STAFF SUBMITTAL

COMMISSION ON WATER RESOURCE MANAGEMENT

Approval of Stream Diversion Works Permit Application (SDWP.5083.6) and  
Special Conditions, East Maui Irrigation Company, LLC,  
Abandonment of Stream Diversion Nos. 152, 247, 246, 191, 264, 240, 242, 217, 155, 225, 330,  
331, 324, 322, 321, East Maui Irrigation System (Category 1),  
Honopou, Hanehoi (Puolua), Pi'ina'au (Palauhulu), and Wailuanui Streams, Maui,  
TMK: Various; and

## SDWP.5083.6 Honopou, Hanehoi (Puolua), Pi'ina'au (Palauhulu), and Wailuanui Streams, Maui

3. Wailole Intake at New Hamakua Ditch (NH-23, Div.246.6). Water is diverted from East Honopou Stream at Intake NH-23 (Wailole Intake) into the New Hamakua Ditch (tunnel).

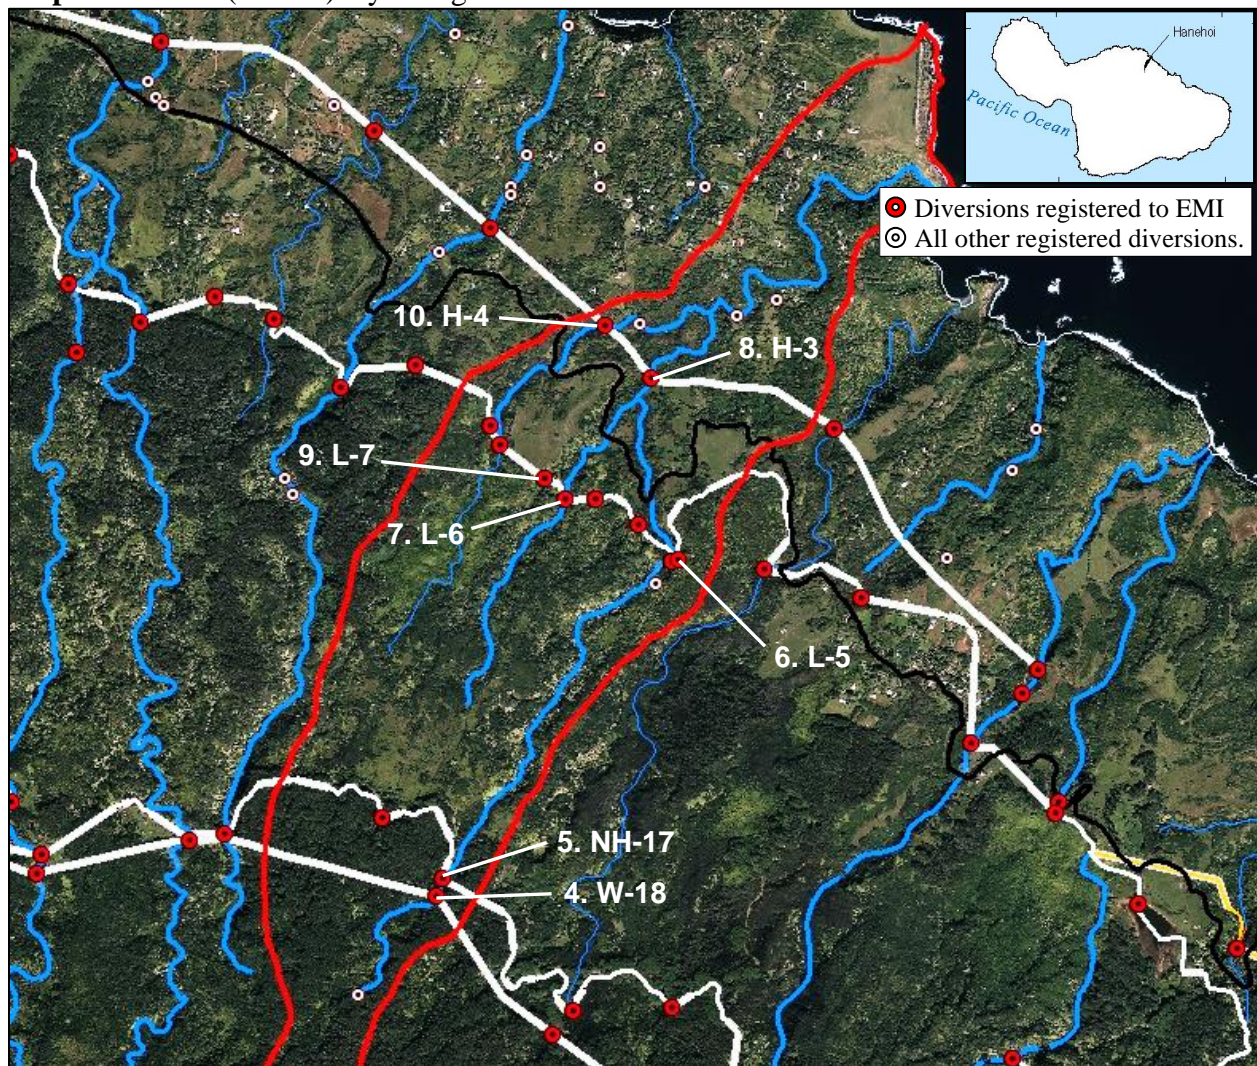
Proposed Modifications: Construct a 45-degree concrete ramp on the left bank, downstream of the bypass channel for the main channel to the left of the sealed intake (see red arrow in photo above).

10. School Intake at Ha'ikū Ditch (H-4, Div.225.6). Water is diverted from West Hanehoi Stream at Intake H-4 (School Intake) into the Haiku Ditch (tunnel).

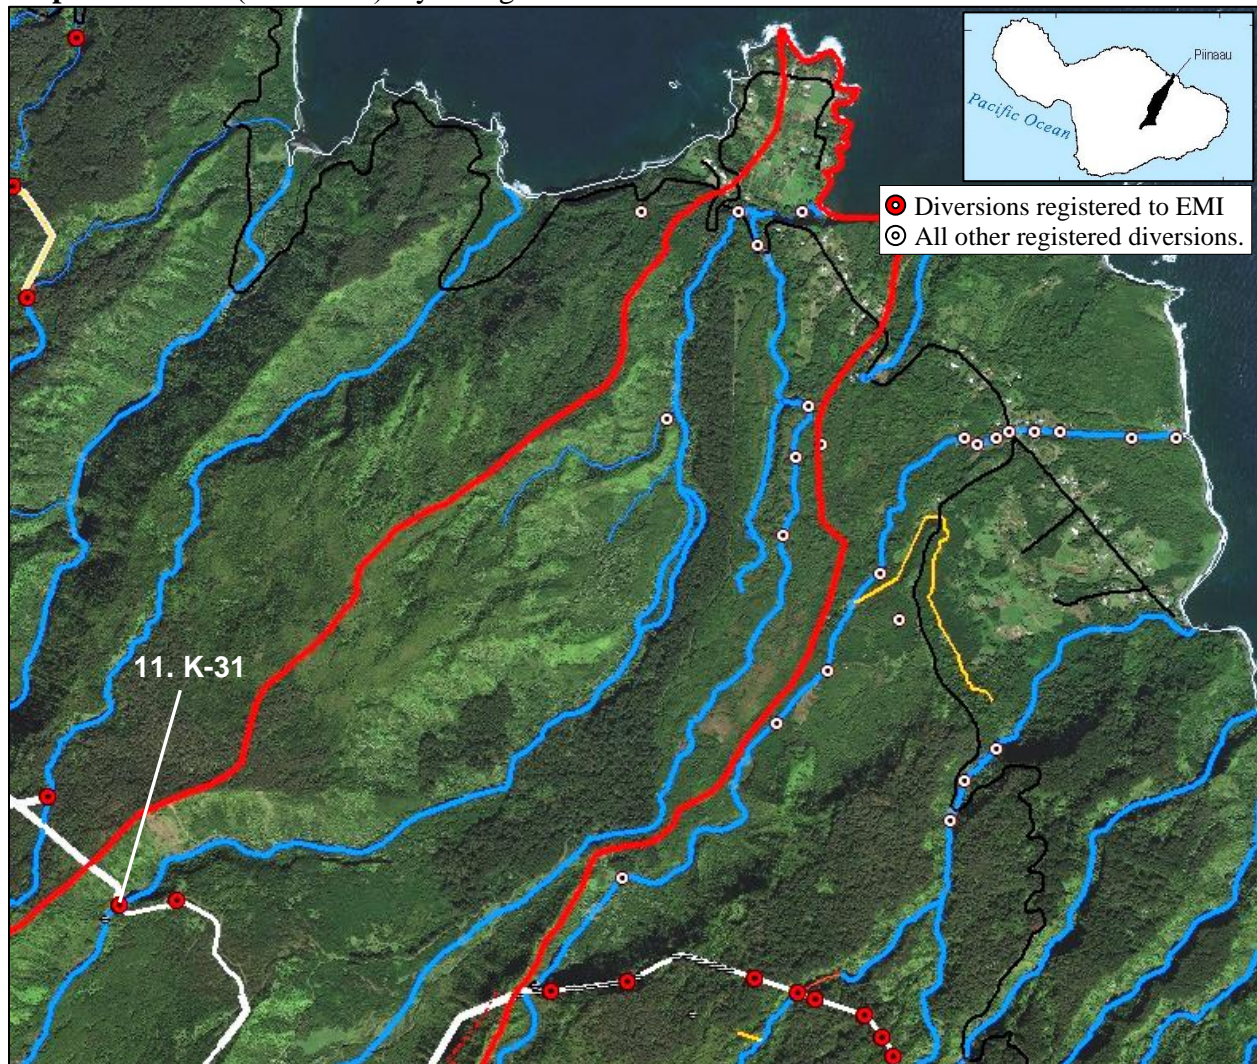
Proposed Modifications: 1) Remove dam wall and sluice gate infrastructure; 2) Remove the sediment basin wall (see red arrows in photos above).

- i. School Intake at Ha'ikū Ditch (H-4, Div.225.6): 1) Remove dam wall and sluice gate infrastructure; 2) Remove the sediment basin wall.
  - j. Pi'ina'au Intake at Ko'olau Ditch (K-31): Remove the low dam just downstream of the sealed intake.

11. Pi'ina'au Intake at Ko'olau Ditch (K-31, Div.330.6). Water is diverted from Pi'ina'au Stream at Intake K-31 into the Ko'olau Ditch system.

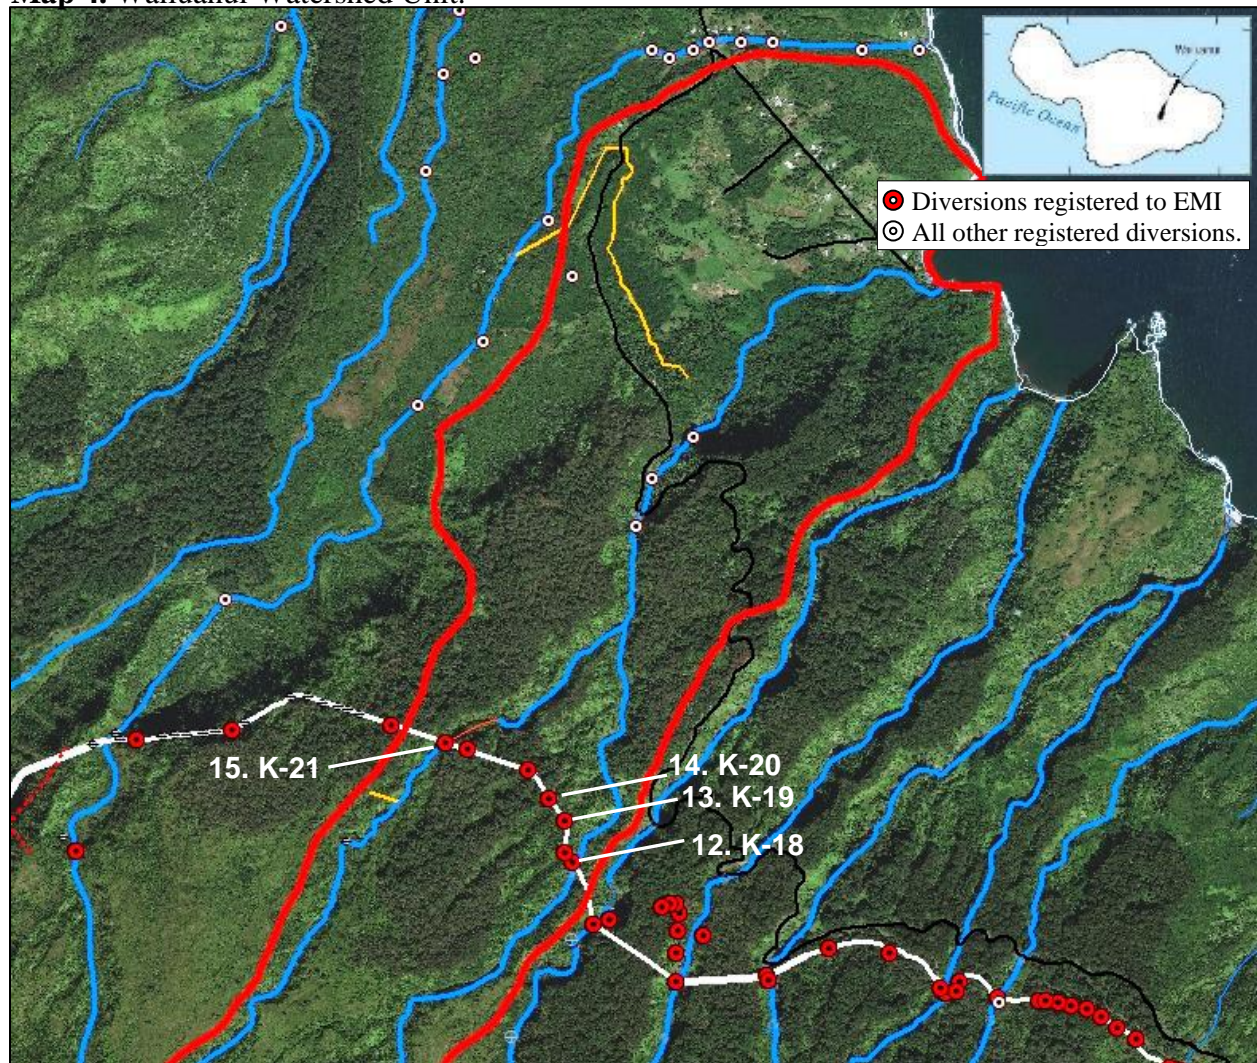
Proposed Modifications: Remove the low dam just downstream of the sealed intake (see red arrows in photos above).

### Intake L-5 Hanehoi stream Lowrie ditch

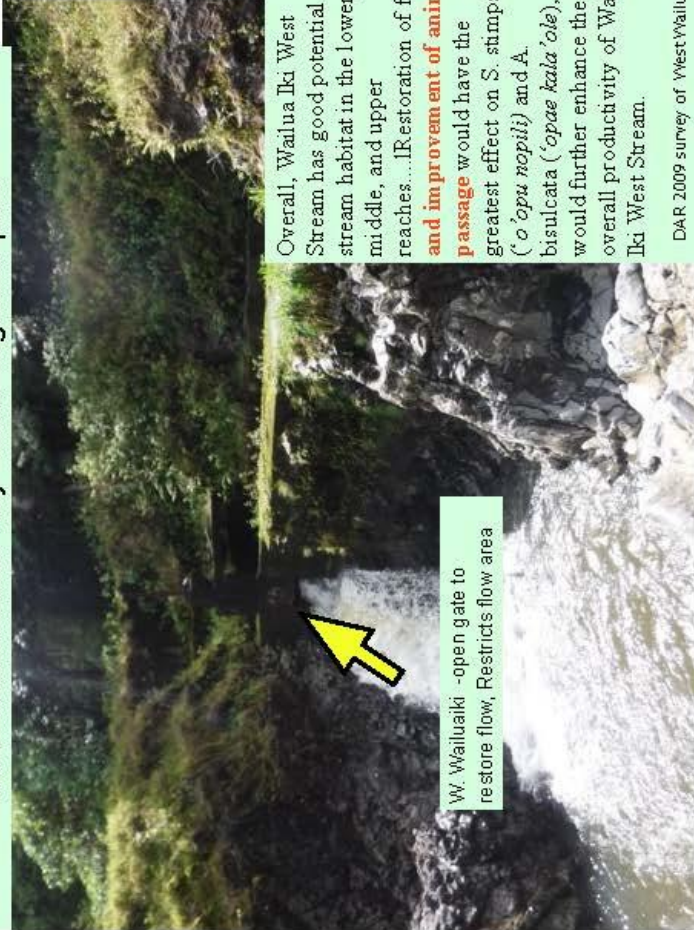
**Recommendation:** Diversion structure impedes natural stream flow and has a slight overhang. It should be removed and a flatter bypass created over the Lowrie ditch to allow more natural grade of stream bed

Proposed Modifications: 1) Seal and/or cap downstream end of PVC bypass pipe; 2) Seal leaks into Lowrie Ditch on upstream end of bypass channel.

Intake K-21 W. Wailuanui stream Ko'olau ditch  
on State land

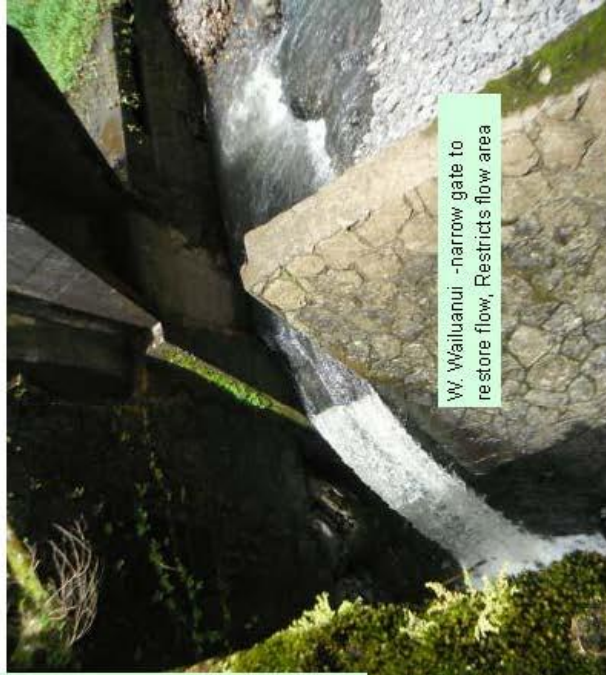
- Remove unneeded dam structure (photo below) to restore more natural flow patterns and avoid stagnant pools that breed mosquitos during low flow periods

Proposed Modifications: Per the Island Geotechnical Engineering report, dated September 1, 2021, cut and remove the dam, leaving intact 4-feet from the rockwall-supported embankment on the left bank, and tempered 1:1 to the stream bed level to keep the rockwall supported embankment in good condition. If the base of the dam, once cut, is found not to be hard bedrock, the area may need to be capped with high-strength concrete to prevent erosion/scouring. Furthermore, large boulders may be placed at the base of the rockwall supporting the embankment to prevent scour of the embankment.

Hanehoi/Haiku ditch -Narrow open gate is only pathway for restored flow and streamlife migration. Restricts flow area

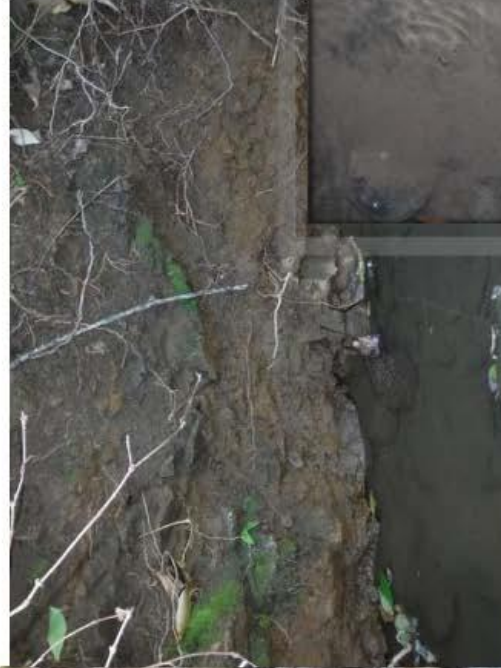
**Recommendation:** remove unneeded dam/ catch basin structures
